Dear Keith

**Notice of exhibition of Response to Submissions (RtS)
Residential development with in-fill affordable housing at 16-24 Lord Street and 21-27
Roseville Avenue, Roseville (SSD-78996460) (Application) (Site)
Development application submitted by HPG General Pty Ltd (Hyecorp)**

Figure 9 Desired future character

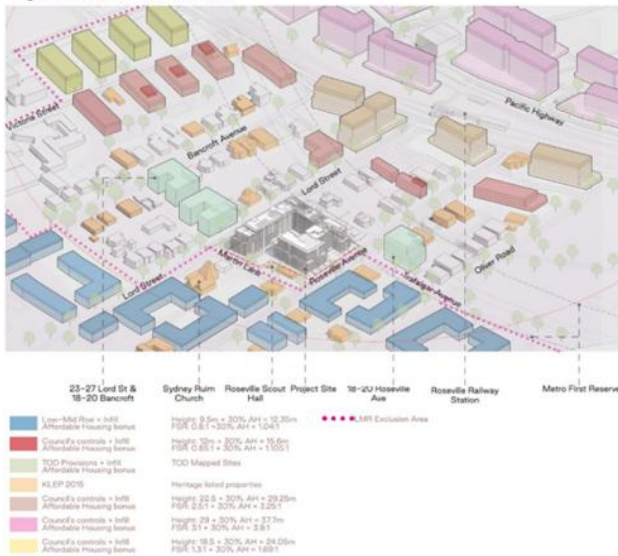
6.1 The Figure 9 Desired Future Character Drawing is set out below (**Future Character Drawing**). It is referred to in numerous reports notably on page 41 of the Urbis RtS and the HIS Addendum. This appears to justify the proposed development.

6.2 It is a very different drawing from that contained on page 56 of the EIS where substantial development was shown around it however apparently the new proposal will still just “fit in”.

6.3 I would submit that the use of the Future Character Drawing to “justify” the refined proposal in the context of the commentary is misleading as many key factors, some of which are known to Urbis and the DPHI, have been ignored or the RtS has conveniently remained silent on them.

6.4 Further many aspects of the drawing are incorrect and self-serving, and it cannot be relied upon to justify “*future character*”.

(1) **18-20 Roseville Ave ‘mapped site’**.

- (a) there is no mention of the position that the application in relation to this site being eDA0254/25 has been refused by the Ku-ring-gai Local Planning Panel (noting refusal occurred prior to the lodgement of the RtS);
- (b) no mention of the detailed reasons for the refusal; and
- (c) no mention that with respect to this application, Sydney Metro concurrence could not be obtained by that developer.

Accordingly, use of this site to support future character is arguably flawed and should be discounted as part of the merits assessment.

(2) **LMR Assumptions** to support future character to the north and east. The following matters are relevant:

- (a) the assumptions regarding the possible use of LMR to the north and east of the project along Roseville Avenue, assumes low level development (up to 12.35 metres with affordable housing) is feasible and given existing underlying values, owners would sell on this basis. In other words, given the low FSR it makes no comment on whether a developer could feasibly make a development on those sites “*stack up*” with such a low FSR;

- (b) the likelihood of LMR provisions being used to develop from 9.5 to 12.35 metres is also exacerbated by site constraints including flooding constraints identified in the Applicant’s own reports, tree canopy aspects and the heritage aspects identified in the HIS Addendum being the heritage requirements of the HCA where these sites are situated being the KRG LEP 2015 and DCP requirements;

- (c) even in the unlikely event those sites could be developed the transitioning would still be substantial (approximately 30.1 metres down to 9.5/12.35 metres) so not affording an appropriate transition;

- (d) the LMR exclusion maps extracted clearly show that the first line of houses from Oliver Rd north up to Trafalgar Ave on the eastern side of that road are in the LMR exclusion area. In that regard the Future Character Drawing is misleading in that the scaling does not show the full length of the housing set back which will not permit the LMR and be limited to 9.5m high along there and assumes development of the scale disclosed can be achieved behind that row of homes. Note the comparison of the scaling of 22 and 24 Roseville Avenue used which is not extrapolated further up the street for the excluded rows of houses. DPHI officers should be aware this would be evident from the widths of the Deposited Plans for those relevant sites.

Accordingly, this aspect of the Future Character Drawing detailing the sites north of Roseville Ave to support future character is arguably flawed and should be discounted as part of the merits assessment.

- (3) **18-20 Bancroft Avenue & 23-27 Lord Street mapped site** - the reference to the 'mapped' SSD site is interesting given the following matters and, in the circumstances, should not be relied on for "*future character*" purposes noting:

Accordingly, this aspect of the diagram detailing this "mapped site" south of the development site to support future character is arguably flawed and should be discounted as part of the merits assessment.

(4) **Sydney Metro Tunnel Reserves**

- (a) The Future Character Drawing now depicts in part the NSW Metro line cutting a swathe through Eastside Roseville at some of the lowest points in that line as is clear from the drawings and Submissions made.

- (b) Contrary to the drawing's pictures, development as indicated in the Drawing is just not feasible given underlying land value prices as would be apparent from VG figures for this area which DPHI assessing officers have available to them.

- (c) Accordingly the proposed development will be a one-off in the area due to restrictions around the Sydney Metro line below and to suggest otherwise is not a balanced or technical view supported by what has occurred and is detailed in the Submissions.

- (d) Has the DPHI validated such statements with Sydney Metro or undertaken any analysis based on VG values for Eastside Roseville land as part of its assessment? If not, it would be reasonable to do so.

(5) **Church Sites Discrepancy**

- (a) There are 2 Church sites, Roseville Uniting Church at 7A Lord Street and St Andrews Anglican Church and Diocese at the corner of Hill Street and Bancroft which sit above the Metro Reserves.
- (b) These appear on the Drawing to be shown as "Council controls + in-fill affordable housing bonus" in red however are unlikely to be developed in the manner shown if at all.

(6) **Juliet Development at 64 Pacific Highway**

- (a) If I am reading it right, the Future Character Drawing also seems to show Hyecorp's Juliet project as not subject to the pink Council affordable controls when based on the planning maps it clearly is.
 - (b) Why was this not coloured pink as well? Perhaps not to highlight Hyecorp could have amended the plans and included an affordable housing component? It is noted that based on social media ads just over 60% of the project has sold off the plan. If correct, does this omission on the Drawing also concern the DPHI?
- (7) On one analysis, the Future Character Drawing is cynical, and misleading given the controversial nature of the proposal and on a lesser level the consultants have sought to selectively prepared the Diagram to support their case.
